Access Compliance Report Public Rights-of-Way (Curb Ramps)

Main Street: BRUNSWICK_WAY Cross Street: LA_LIMONAR_DR Location: E

ADA ID: RPRK211013135012 Ramp Type: Type 4 - Parallel Initial Pass/Fail: Fail Overall Compliance: No Severity Score: 30

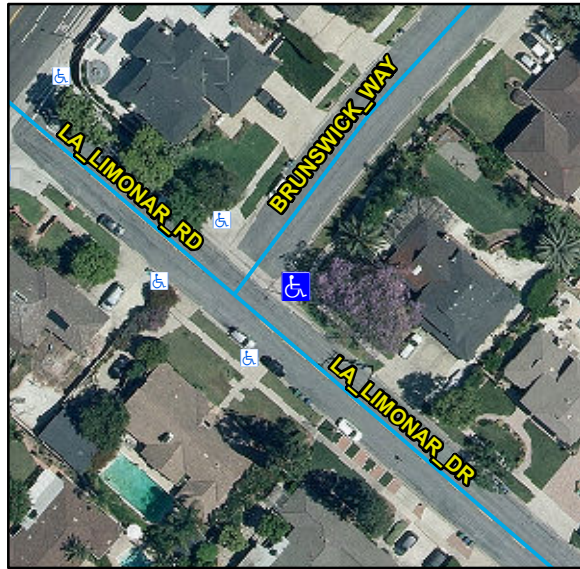
Compliance	Description	Data	Compliance	Description	Data
N/A	Ramp Length LT (in)	101	N/A	Ramp Length RT (in)	83
Yes	Ramp Width LT (in)	126	Yes	Ramp Width RT (in)	126
Yes	Ramp Run Slope LT (%)	6.1	Yes	Ramp Run Slope RT (%)	0.3
No	Ramp Cross Slope LT (%)	4.6	No	Ramp Cross Slope RT (%)	7.1
N/A	Landing Present	N/A	N/A	DWS Provided	N/A
N/A	Landing Length (in)	N/A	N/A	DWS Contrast	N/A
N/A	Landing Width (in)	N/A	N/A	DWS Length (in)	N/A
N/A	Landing Run Slope (%)	N/A	N/A	DWS Full Width	N/A
N/A	Landing Cross Slope (%)	N/A		DWS Offset Type	N/A
N/A	Landing Movement Obstructed?	N/A	N/A	DWS Offset Left (in)	N/A
	Landing Movement Type	N/A	N/A	DWS Offset Right (in)	N/A
N/A	Landing Shared	N/A			
N/A	Clear Space	Yes			
N/A	Clear Space To Crosswalk (in)	N/A			
N/A	Marked Crosswalk 1	No	N/A	Marked Crosswalk 2	No
	Crossing 1 Direction	SW		Crossing 2 Direction	NW
	Marked Crosswalk 1 Width (in)	N/A		Marked Crosswalk 2 Width (in)	N/A

Remove & Replace Curb Ramp With Two New Directional Ramps or Equivalent.

R304.5.3, STD 1115
